Proposed Horowhenua District Plan

Rural Environment

Officer Right of Reply and Response to Commissioners Questions

Planning Map 7

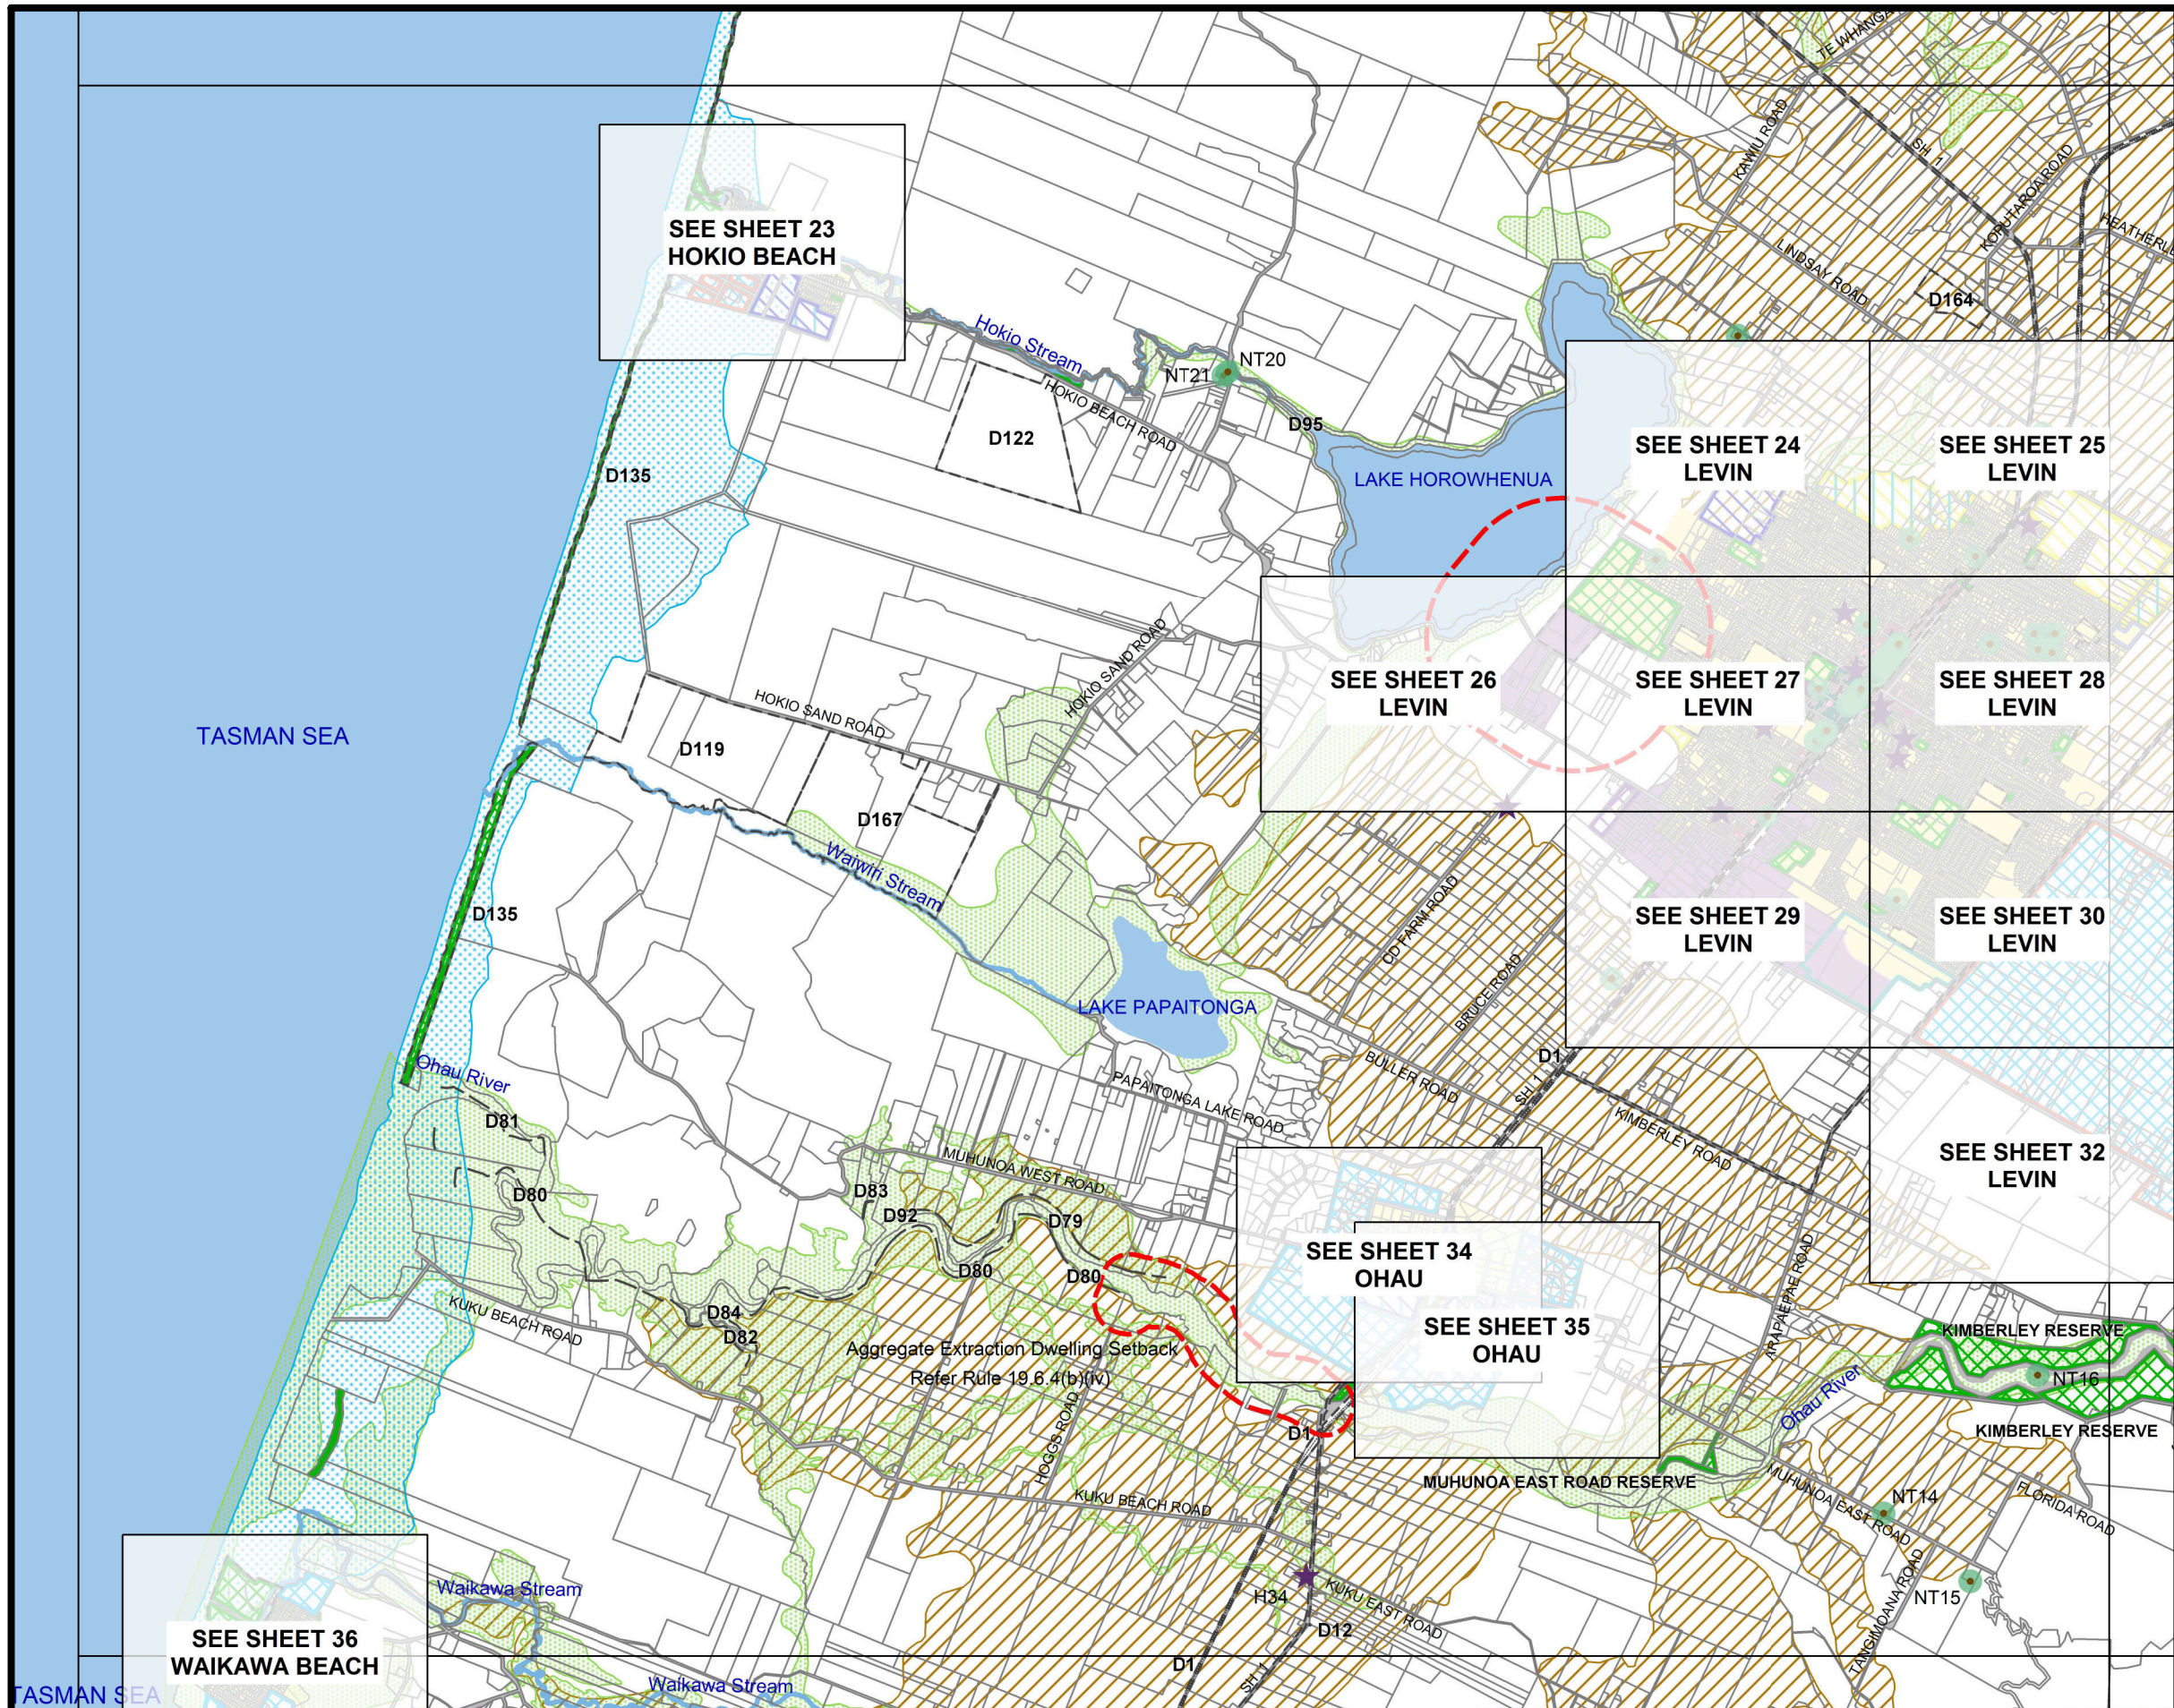
Amend Planning Maps 7, 8, 33, 34 and 35 by adding a new line indicating the extent of the 200m buffer around the two existing aggregate extraction activities on the Ohau River (see maps in Appendix 1).

- (iv) 200 metres from existing aggregate extraction activities on the Ohau River (area shown on the Planning Maps).
